MIL "ON" DTC P0401

Service Category Engine/Hybrid System

Section Emission Control

Some 2010 – 2012 model year Prius vehicles equipped with a 2ZR-FXE engine may exhibit a MIL "ON" condition with Diagnostic Trouble Code (DTC) P0401 (*Exhaust Gas Recirculation Flow Insufficient Detected*) present. The Exhaust Gas Recirculation (EGR) Valve has been improved to address this condition.

Figure 1.

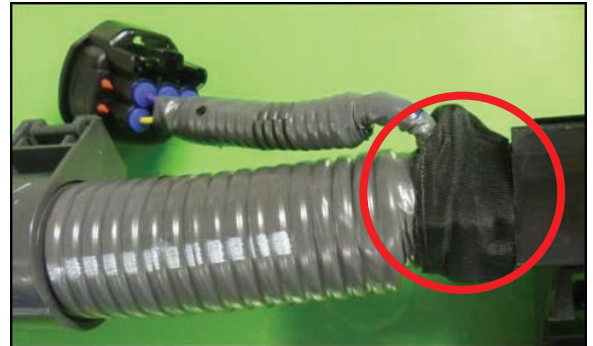
3. Modify the wire harness using the following procedure.

A. Remove the vinyl tape wrapped around the main harness and the EGR harness.
